Landlord's Approval Review

Essence Salon Suites

Washington Park Plaza

Project Scope: New sign installed

AFTER SIDE

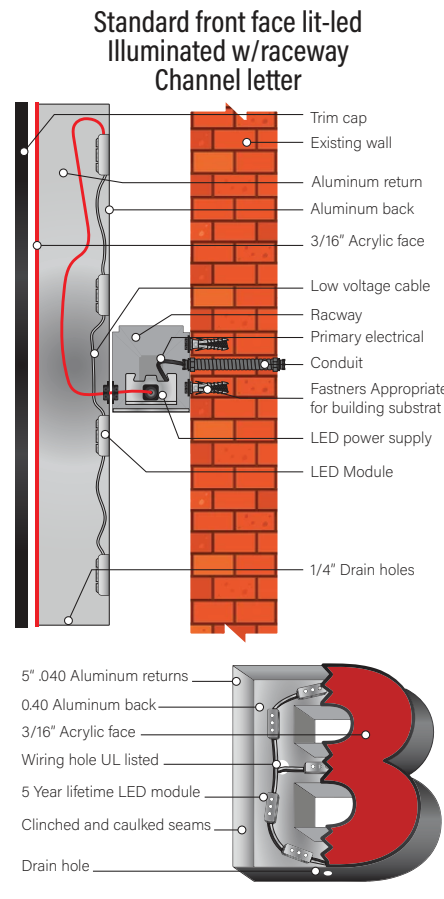
**RACEWAYS MUST BE PAINTED TO MATCH BACKGROUND/SIGNBAND COLOR.
 SIGN MUST MATCH D.B.A. IN LEASE.**

AFTER FRONT

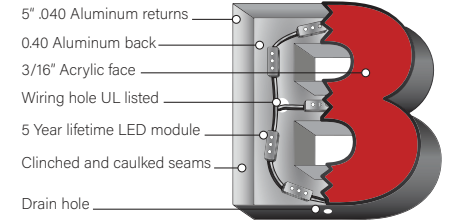
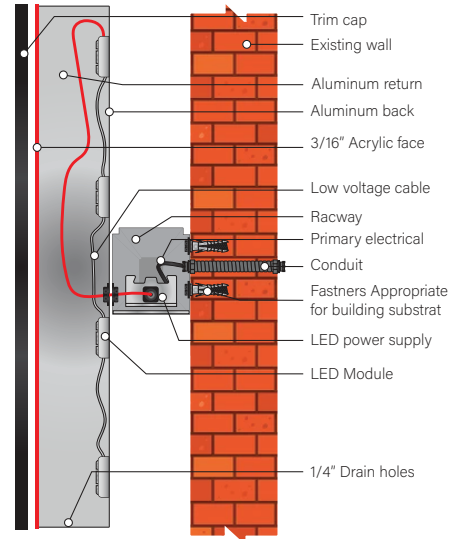
RACEWAY MUST BE PAINTED TO MATCH BACKGROUND.
